APPLICATION NO.	FILING DATE	FIRST NAMED INVENTOR	ATTORNEY DOCKET NO.	CONFIRMATION NO.
09/553,573	04/19/2000	Gary K. Michelson M.D.	101.0077-00000	3776

Office Action Summary

DETAILED ACTION

FIG. 2

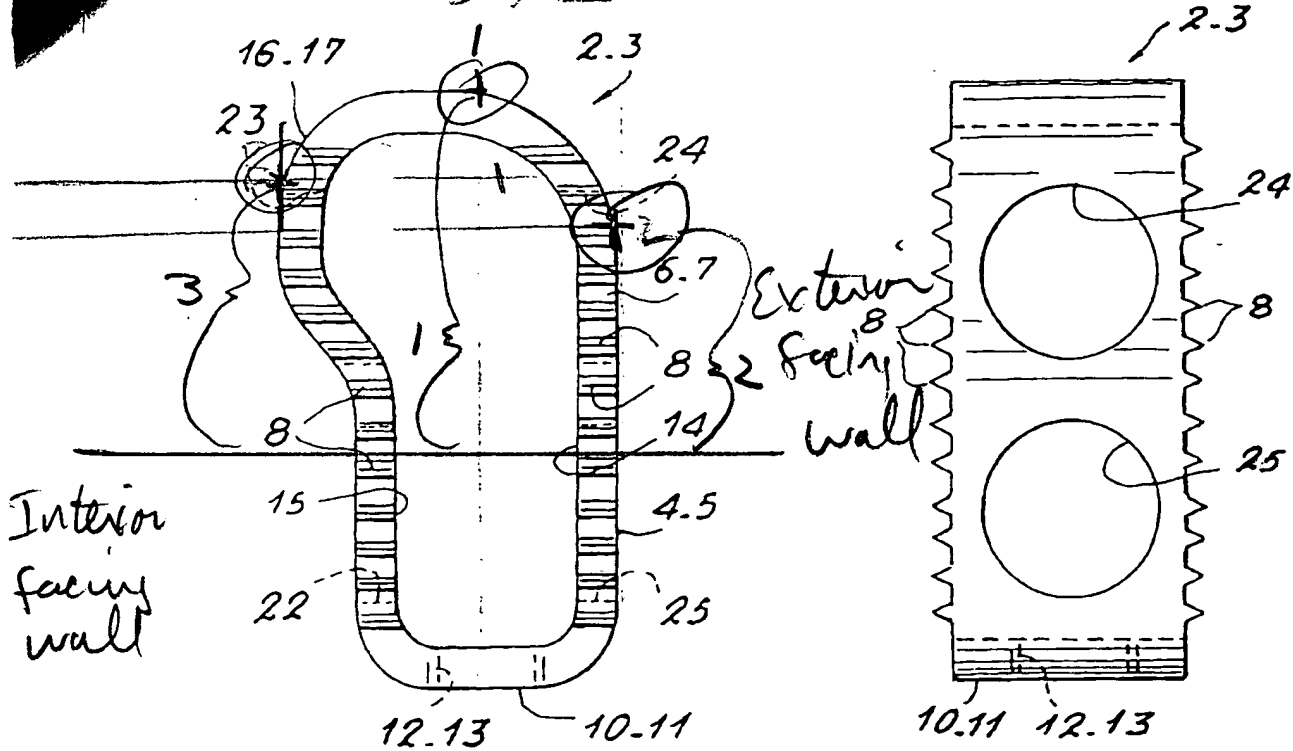
Referring to figure 1, Albert teaches a spinal implant having a width approximately $\frac{1}{2}$ of the maximum width of the vertebral into which it is intended to be implanted. The implant has a first distance that is greater than a second distance and a third distance greater than said second distance. See attachment of Figure 2 with the Examiner's interpretation.
